<b>Subject:</b> VEHICLE SPEED DOES NOT INCREASE WITH ENGINE SPEED AND ATX DOES NOT SHIFT UP OR DOWN	<b>Bulletin No:</b> 05-006/15
	<b>Last Issued:</b> 11/30/2015

2012-2013 Mazda3 (with SKYACTIV A/T)  
2013 CX-5 (with SKYACTIV A/T)

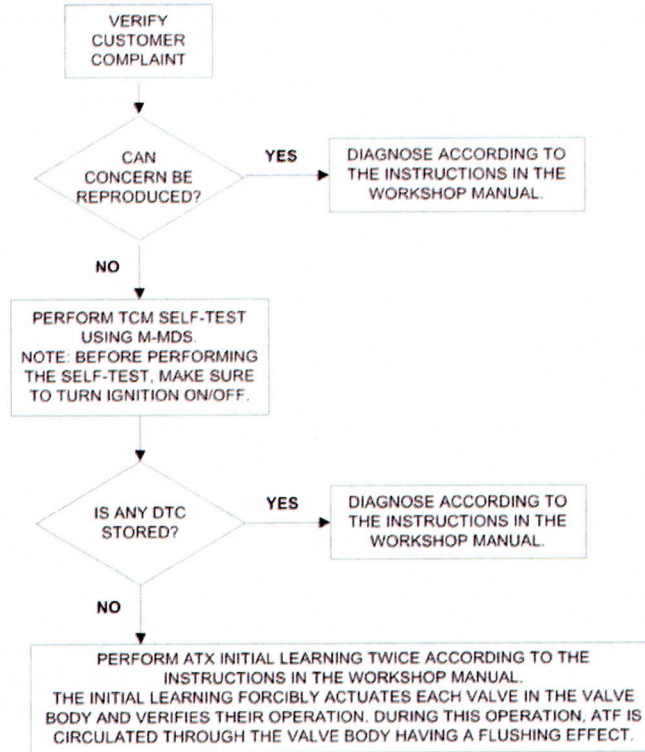
1. Verify customer concern.
2. Follow the chart to determine course of action.
